37 DELANCEY STREET PROPOSED SECOND FLOOR PLAN

1096.01.14(E)

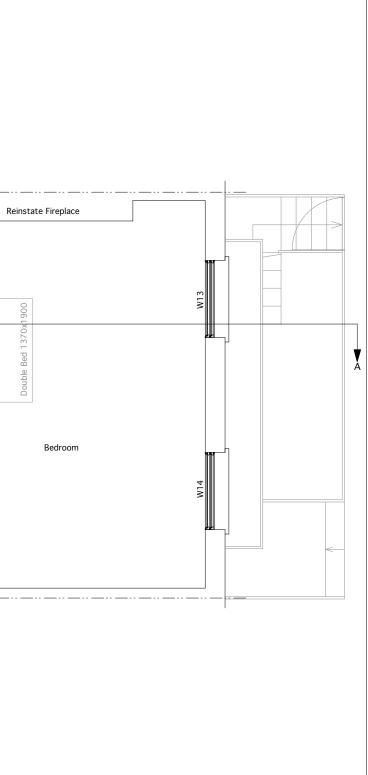
REV to with consultant & 2700.21 /2 Revised re Client Feedback B -02.03.12 Revised to be more inkeeping with existing layout or alia. C - 25.061 /2 Revised with of close twing. Layout of backdows kept represe indicate. a existing D = 0.001.13 Revised window notes ED = 0.100.113 Revised window notes
